## RESPONSE TO AGENCY SUBMISSIONS

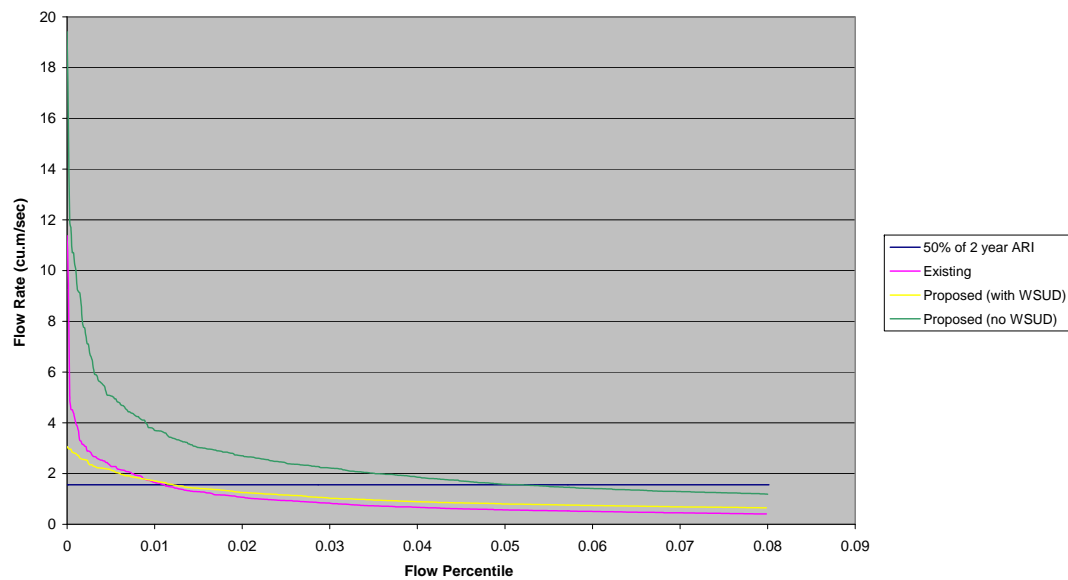
Issues Raised	Response
<ul style="list-style-type: none"><li>▪ The development is not to impact the Nepean River system or Boundary Creek.</li></ul>	<ul style="list-style-type: none"><li>▪ The Environmental Assessment addressed the mitigation of potential adverse impacts on the Nepean River system and Boundary Creek by addressing stormwater quality and quantity management.</li><li>▪ Appropriate Water Sensitive Urban Design measures have been incorporated into the development to ensure that Landcom's stormwater quality objectives are met and to ensure that the proposed development does not have an unacceptable adverse impact on downstream receiving waters.</li><li>▪ Stormwater quantity will be managed on the site through the provision of a dedicated volume of detention sized appropriately to attenuate post-development flows back to pre-development flows for events up to the 100 year Average Recurrence Interval storm event.</li><li>▪ The Stream Erosion Index was calculated for the North Penrith development. The Stream Erosion Index is an acknowledged methodology for establishing the degree of erosion hazard associated with a modified flow regime and is directly related to the increased duration of flows exceeding a critical flow threshold (50% of the 2 year ARI peak flow).</li><li>▪ The existing scenario XP-RAFTS model estimates the existing 2 year ARI peak flow from the site to be 3.1 m<sup>3</sup>/s. Accordingly, a critical flow threshold of 1.55 m<sup>3</sup>/s was adopted for Stream Erosion Index calculations.</li><li>▪ Peak flow estimates from the site were taken from MUSIC models representing the proposed site conditions with and without Water Sensitive Urban Design measures. The MUSIC models used actual rainfall data from years 1998 to 2005 inclusive and included a series of "wetter than average" rainfall year. A chart showing the Stream Erosion Index is included below.</li></ul>

Issues Raised	Response
<p>■</p>	<p>■ A Stream Erosion Index of 4.6 was calculated for the proposed scenario without WSUD whilst a Stream Erosion Index of 1.1 was calculated for the proposed scenario with WSUD. Based on the above Stream Erosion Index for the proposed development with WSUD scenario, it is unlikely that the North Penrith development will have any significant adverse impact on the existing erosive potential of Boundary Creek.</p> <p style="text-align: center;"><b>Stream Erosion Index</b></p>
